SUBJECT: JOSEPH M. FARLEY NUCLEAR PLANT, UNIT 1, ISSUANCE OF AMENDMENT
RE: CYCLE 16 EXTENSION REQUEST (TAC NO. MA5356)

SAFETY EVALUATION BY THE OFFICE OF NUCLEAR REACTOR REGULATION
RELATED TO AMENDMENT NO. 143 TO FACILITY OPERATING LICENSE NO. NPF-2
SOUTHERN NUCLEAR OPERATING COMPANY, INC., ET AL.
JOSEPH M. FARLEY NUCLEAR PLANT, UNIT 1
DOCKET NO. 50-348

Figure 1 - Risk Increment Illustration

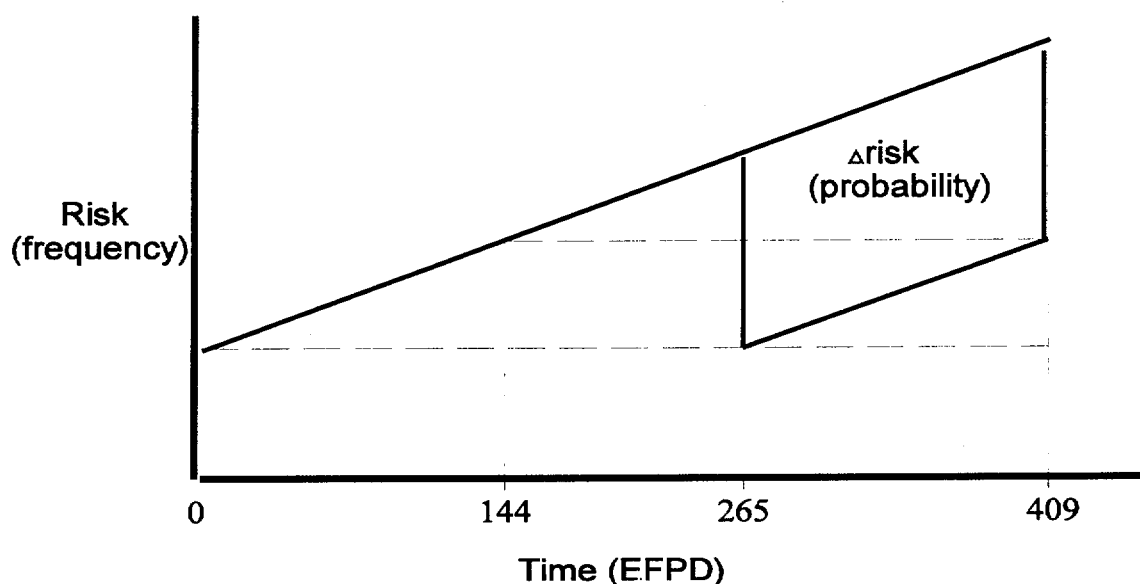
The risk increase that would be caused by not inspecting the steam generator tubes in September 1999 is the difference between the risk estimates for the subsequent part of the fuel cycle as calculated with and without the benefit of detecting and repairing defected tubes in September. A conceptual illustration is shown in Figure 1. This risk increment occurs during the 144 effective full power days (EFPDs) of operation between September 1999 and March 2000. The risk estimate for the inspection case assumed that the 144 EFPDs after a mid-cycle inspection would have the same probability of occurrence for various sized tube flaws as occurred during the first 144 EFPDs following the inspection at the beginning of the fuel cycle.

This assumption is effectively the same as assuming that the flaw growth rate is not accelerating and that the inspection process would not be further improved for the mid-cycle inspection (beyond the capabilities of the inspection done at the beginning of the current cycle). For the case where the mid-cycle inspection does not occur, the risk estimate is based on the projection of flaw probabilities at 409 EFPDs in March 2000. The risk estimation process was further simplified by assuming that the difference in the risk estimates for the two possible conditions in March 2000 was also applicable to each of the 5 preceding calendar months. So, the staff estimated the risk increment for the period as one-half of the difference in risk per reactor year (RY) for the two cases at the end of the fuel cycle in March 2000.
